August 2, 2007

FROM: David C. Dryer, P.E., City Traffic Engineer and Parking Manager

SUBJECT: **4802 Sheboygan Avenue – Rezoning – C2 to PUD (GDP) – Mixed Use Redevelopment**

## Phase 1 – Site C (new WisDOT facility)

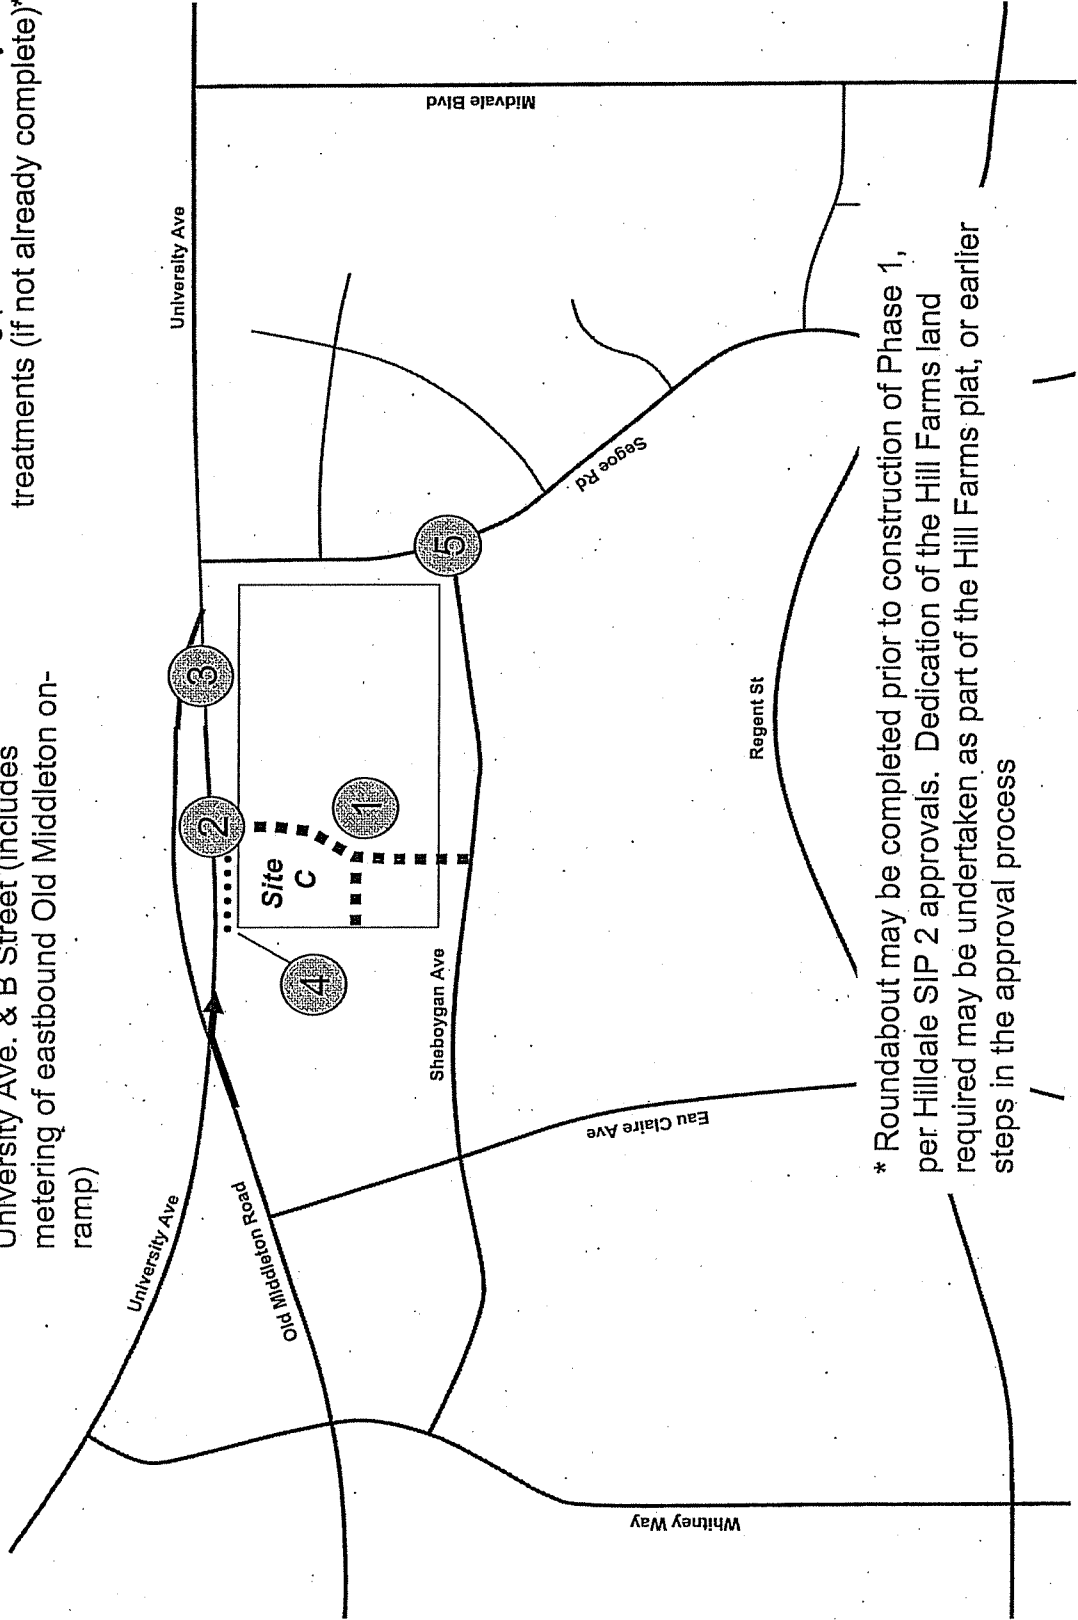
- a. For what is anticipated to be Phase 1 – Site C -- (new WisDOT facility):
  - 1) Construct B Street and D Street including sidewalk and bike lanes on both sides of the street.
  - 2) Construct a new full access intersection and traffic signal at University Ave and B Street (includes metering of eastbound Old Middleton Rd. on-ramp).
  - 3) Study feasibility/timing of University Ave underpass. The Developer/Owner will need to provide this through their own independent engineering study with the City's involvement/concurrence, or provide financial support to the City for this portion of the engineering design study costs as part of an expanded University Ave design.

- 4) Install sidewalk along north side of Site C (University Ave) with trees/landscaping/buffer.
- 5) Install a modern roundabout at Sheboygan Ave and Segoe Rd, including pedestrian and bicycle treatments (if not already complete). Both the Hill Farms site and the Hilldale SIP 2 rely on this intersection improvement to adequately support the development and neighborhood concerns. The State shall dedicate the land required on its site for this roundabout by March 30, 2008 so that the reconstruction can occur in 2008 by the City. The State shall also execute a waiver for their reasonable and proportional share of the costs the roundabout reconstruction and provide a deposit for their estimated share of area wide intersection and traffic signal costs prior to SIP and subdivision sign off.

## Phase 3 – Sites D, E, and F

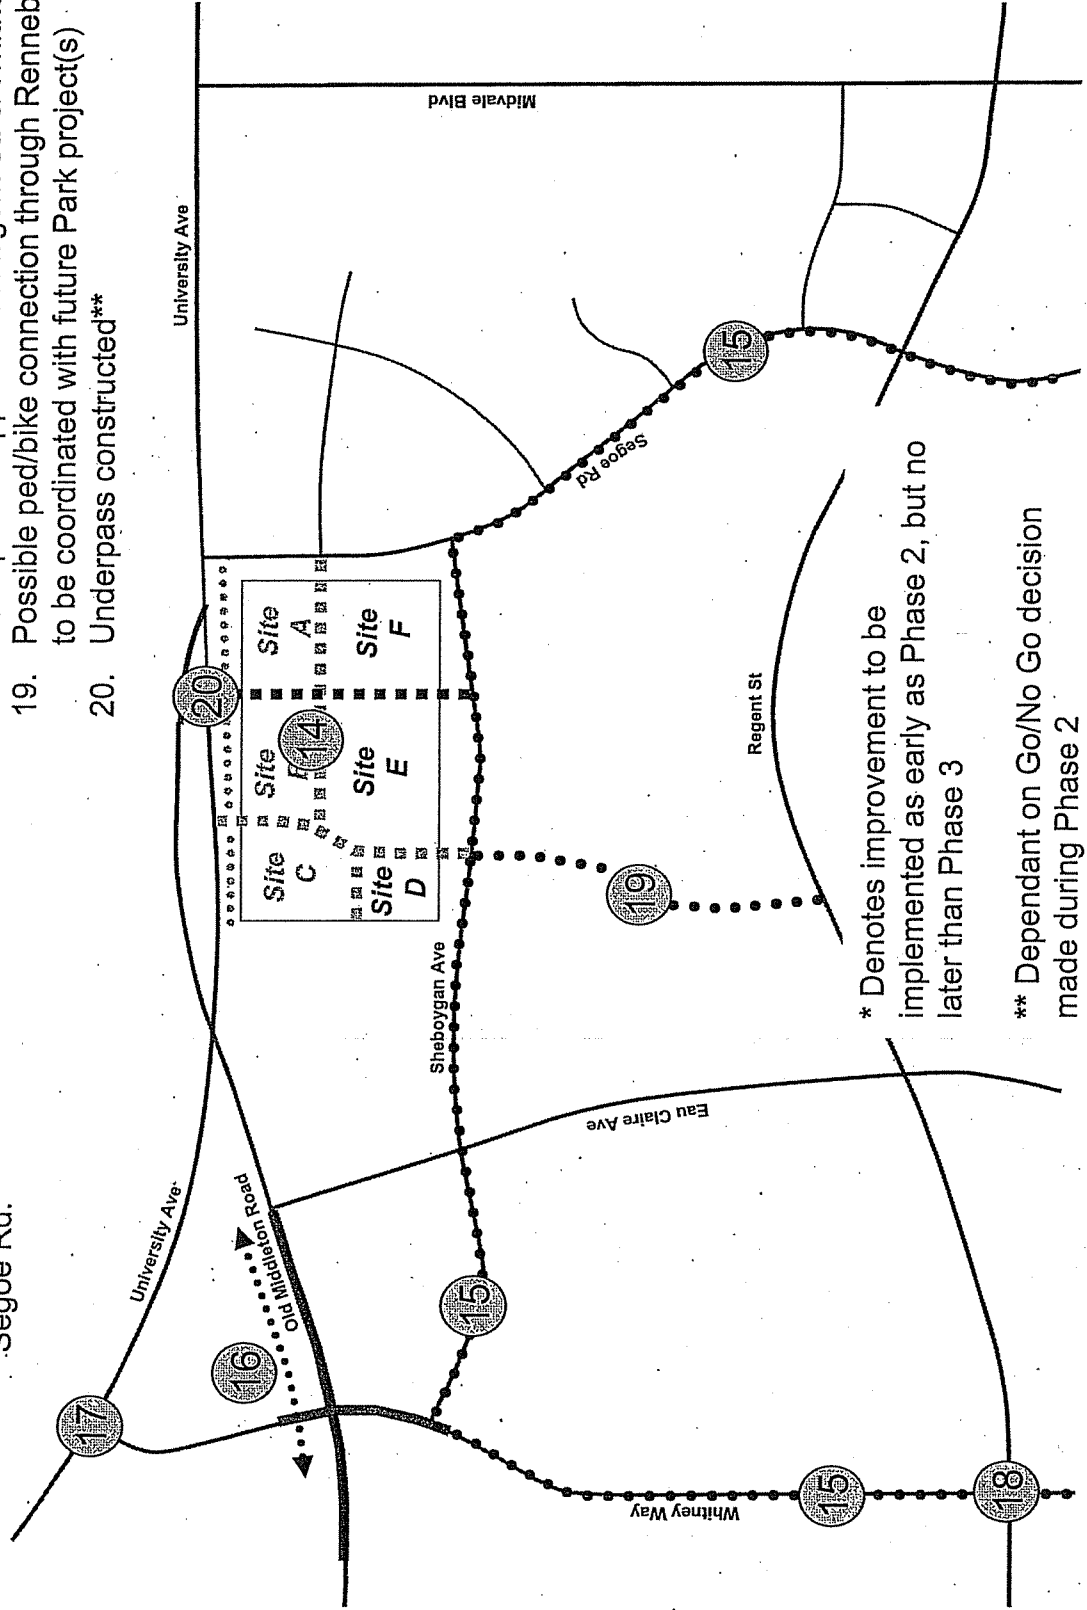
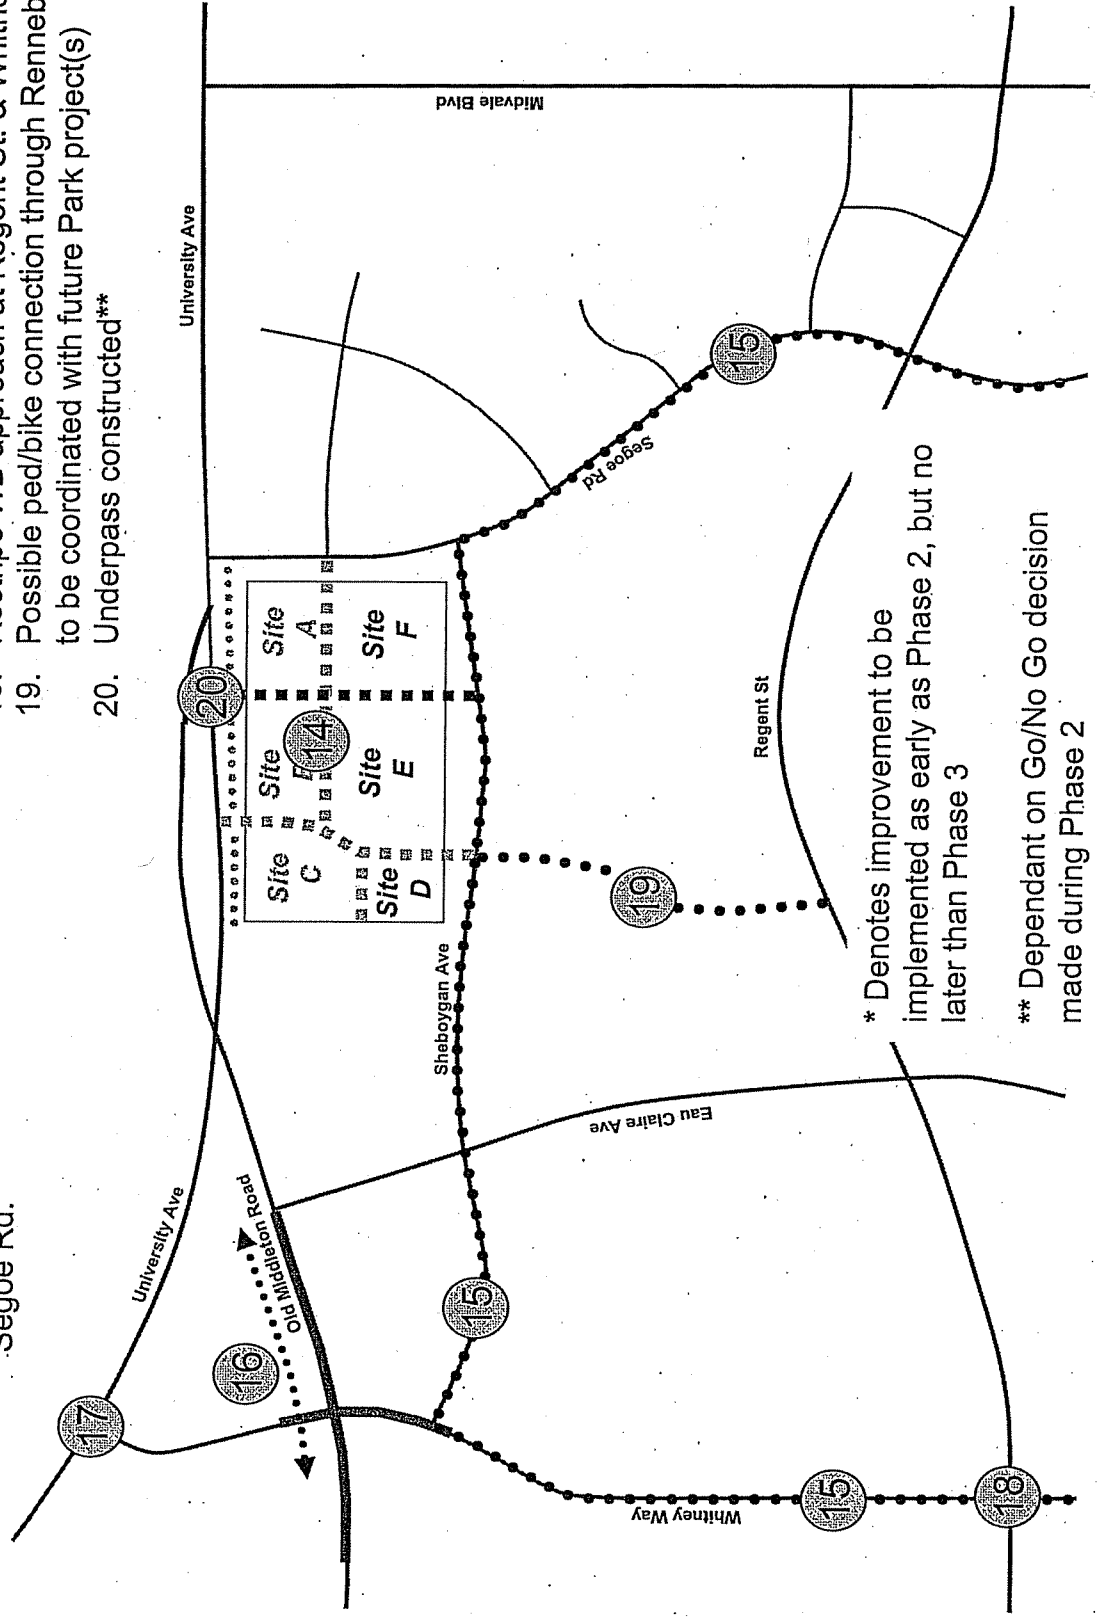
- 14) Construct C Street including sidewalks and bike lanes on both sides of the street.
- 15) Add bike lanes to Whitney Way, Sheboygan Ave, and Segoe Rd. These changes may involve removing on-street parking and widening of the street particularly for Sheboygan Ave.
- 16) Extend the off-street bike path (Blackhawk Bike Trail) from Eau Claire through Whitney Way (this may be implemented as early as Phase 2, but no later than Phase 3).
- 17) Investigate signal phasing/timing changes at University Ave and Whitney Way.
- 18) Evaluate and install if standards met re-striping the WB approach on Regent St at

Whitney Way for 2 lanes.

- 19) Install ped/bike connection through Rennebohm Park both north and south to Sheboygan and Regent St (including the Van Hise school midblock walkway), and east-west from Eau Claire to Segoe Rd. (to be coordinated with future park projects).
- 20) Construct underpass (dependent on Go/No Go decision made during Phase 2).

## Phase 2 – Sites A and B

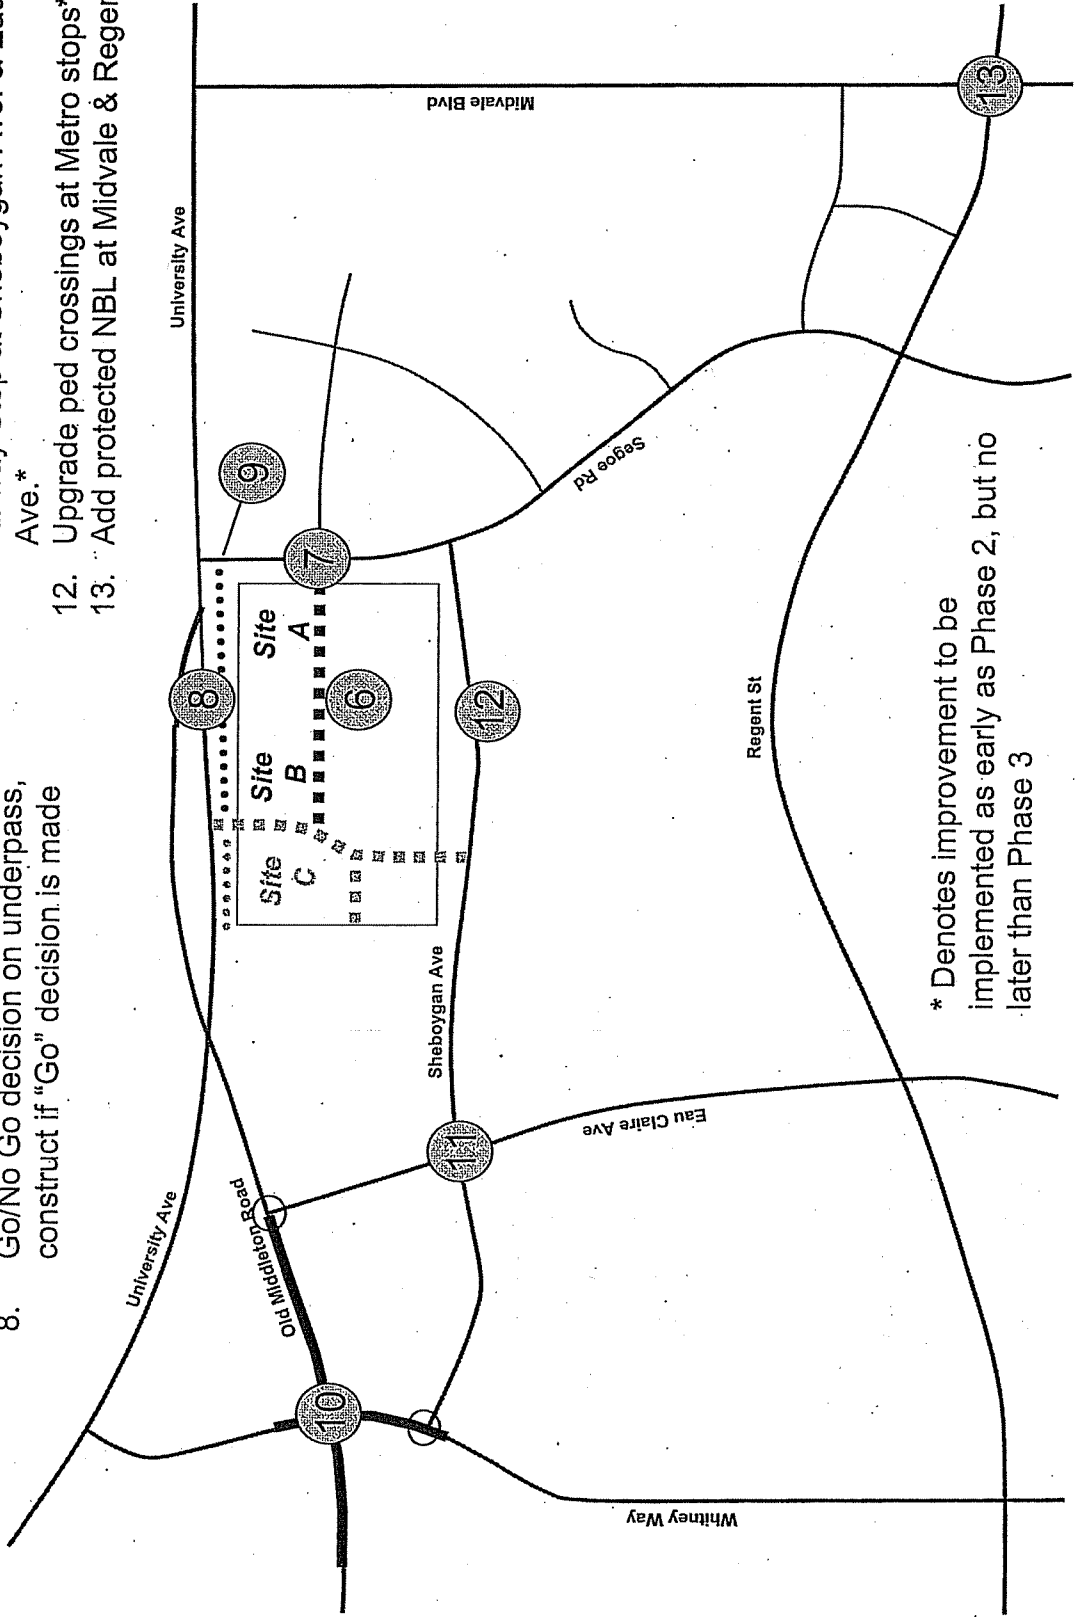
- 6) Construct A Street including sidewalks and bike lanes on both sides of the street.
- 7) Improve the bicycle and pedestrian crossing of Segoe Rd. at Frey St (if not already complete).

- 8) Make Go/No Go decision on underpass with City's concurrence/agreement; construct if "Go" decision is made.
- 9) Install sidewalk along north side of Sites A and B (University Ave) with trees/landscaping/buffer.

- 10) Construct improvements to Old Middleton Rd and Whitney Way; Old Middleton and Eau Claire Ave; and Whitney Way and Sheboygan Ave intersections. The changes to Old Middleton Rd involve a minimum of adding one lane westbound and eastbound and the extension of the Blackhawk Bike Path from Eau Claire to a distance west of Whitney Way; the maximum would be the minimum noted plus dual left turn lanes on Old Middleton Rd and Whitney Way. These changes may involve removing on-street parking and are likely subject to approval by the Office of Commissioner of Railroads.

- 11) Evaluate and install if standards met all-way stops at Sheboygan Ave and Eau Claire Ave (to be implemented as early as Phase 2 but not later than Phase 3).

- 12) Upgrade pedestrian crossings at Metro stops (to be implemented as early as Phase 2 but not later than Phase 3). This may include islands, enhanced markings and signage, curb extensions, and or speed tables.

- 13) Evaluate and install if standards met new signal phase for protected NBL at Midvale and Regent intersection.
